CERTIFICATE OF APPROPRIATENESS PLACARD

Install rear sign; install rear banner art frame

99 N Salisbury St

COA-0129-2022

FIRST BAPTIST CHURCH
exterior lettering

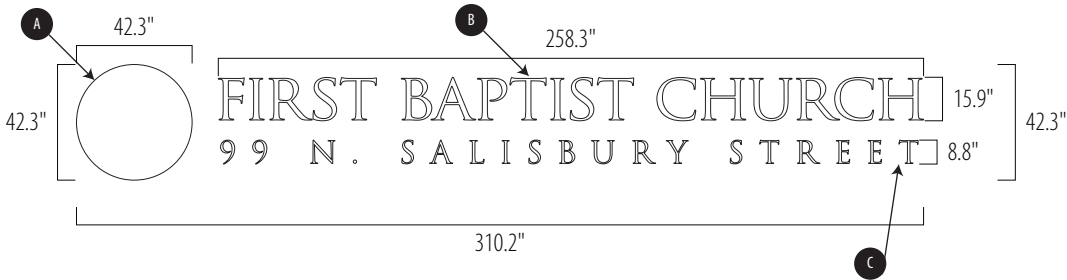
Thanks for submitting a minor work COA for First Baptist Church. The information for the sign and frames themselves and their scale on the overall building façade is very helpful. The one other thing we need information on is how the frame will be attached to the rear wall. A few written sentences describing the type, size, and location of fasteners and their installation through mortar joints rather than through the face of the brick should suffice.

The letters will be stud mounted. We can arrange that they are mounted into the mortar rather than the brick.
